MICRO-STAR INT'L CO.,LTD

MS-V308

Size Custom	Document Description 22_VDDC Phase 5-6 & VDDCI	Rev 2.2
Date: Monday, December 23, 2013		Sheet 22 of 26

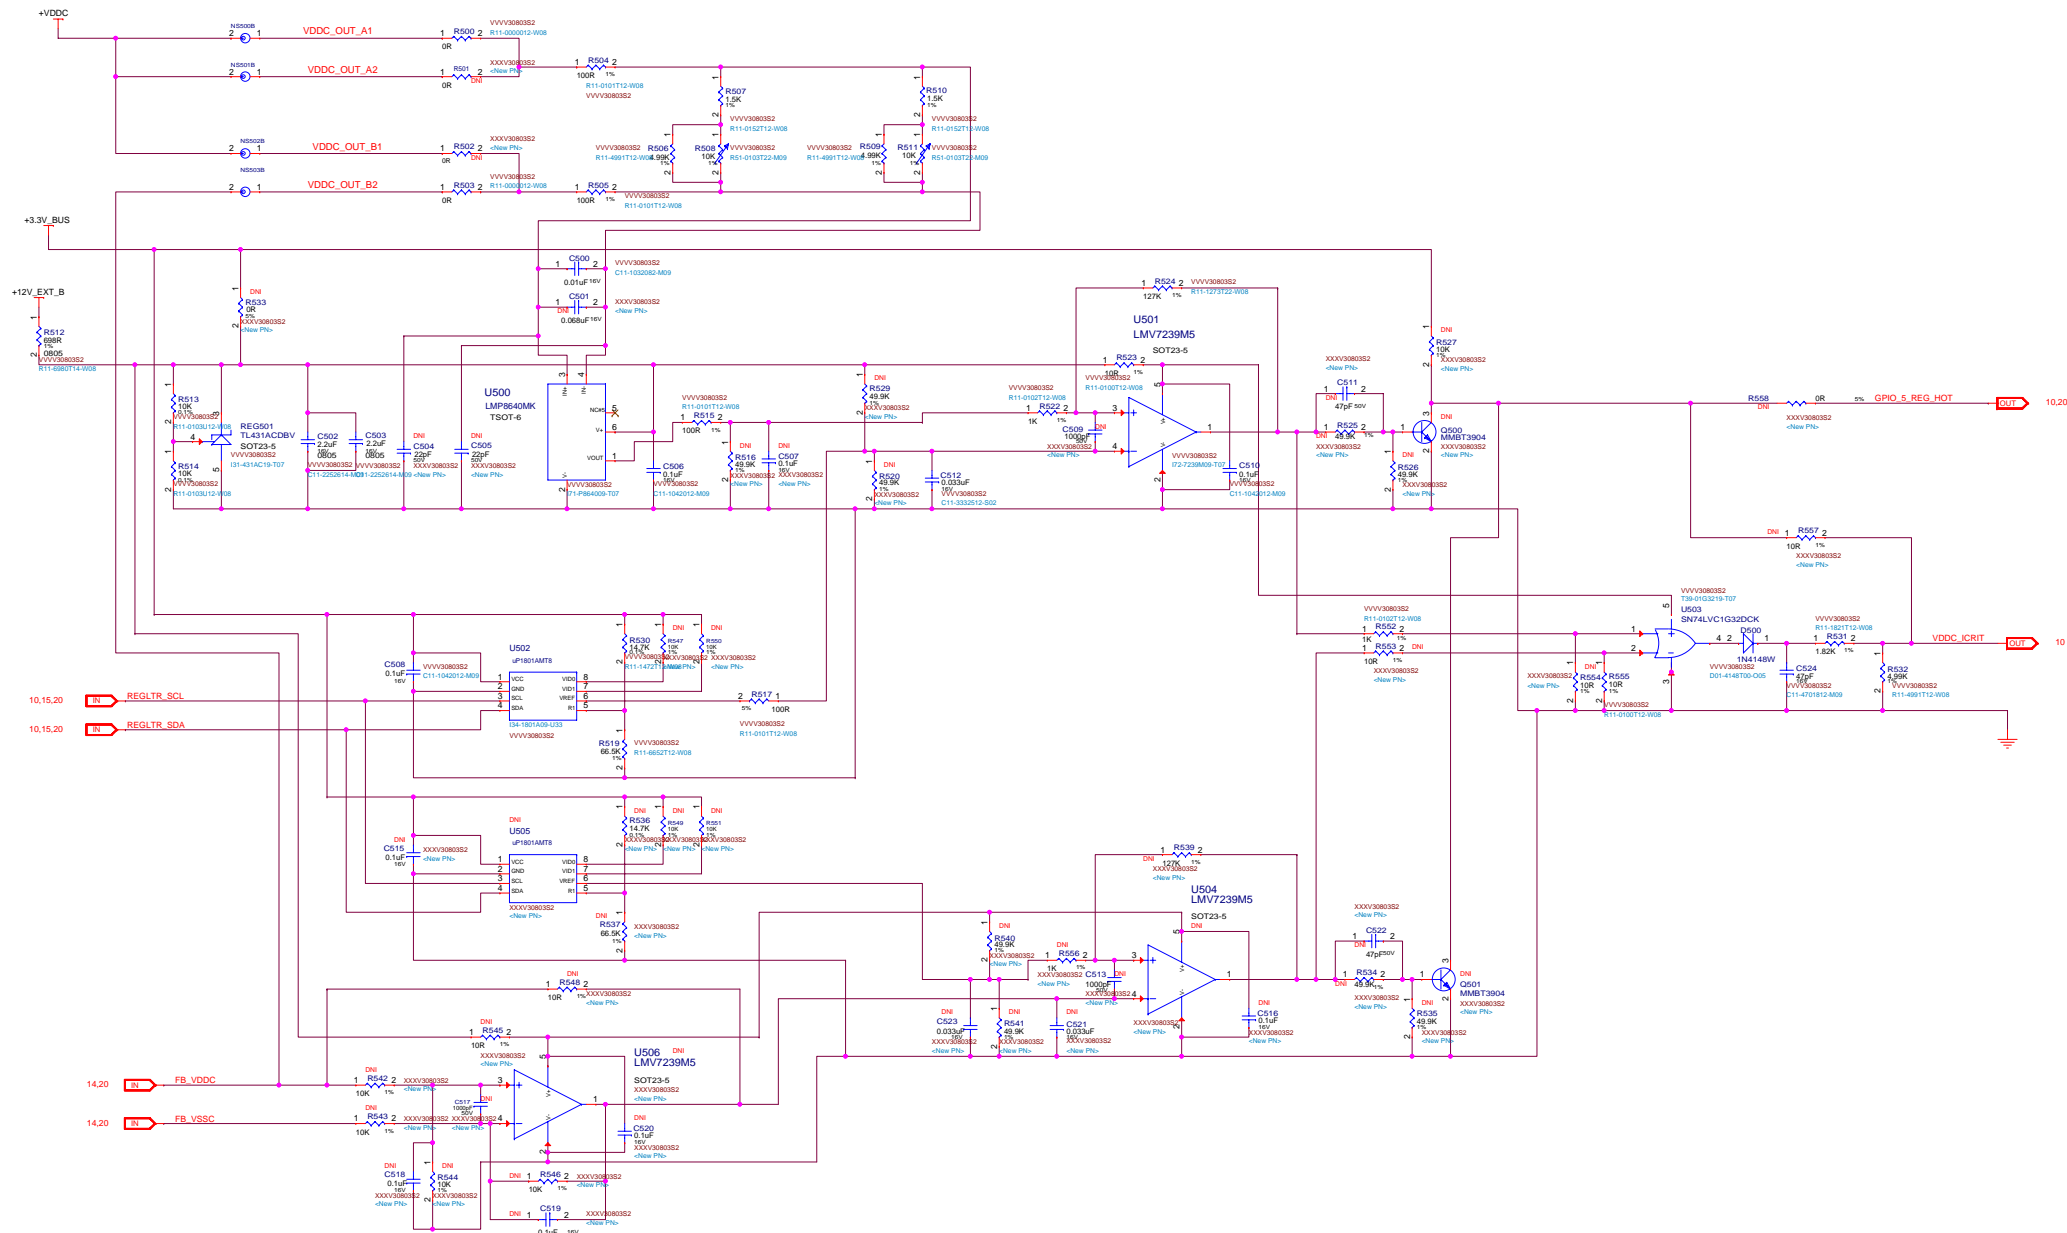
USE Q203 2020023005, R506, R549, D11719
AND C3003 FOR CHEAPER FAN CONTROLLER.
REQUIRES BIG CHANGE IN FAN TABLE.

POWER UP SEQUENCING

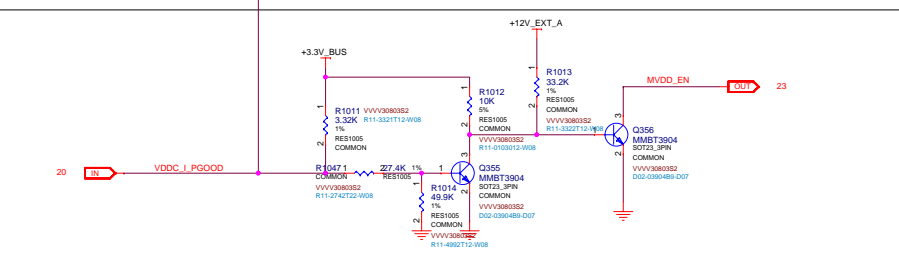
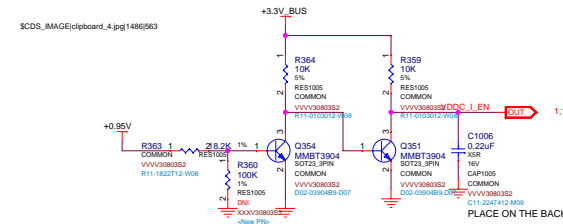
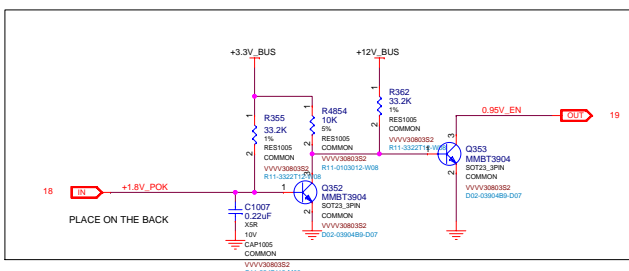
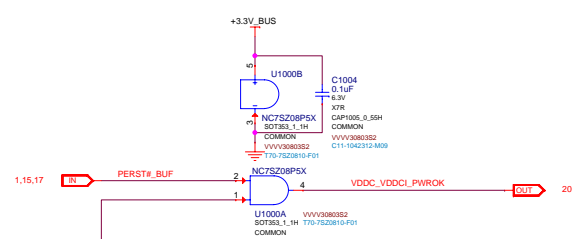
Change net form +0.95_EN to INPUT_RAILS_UP
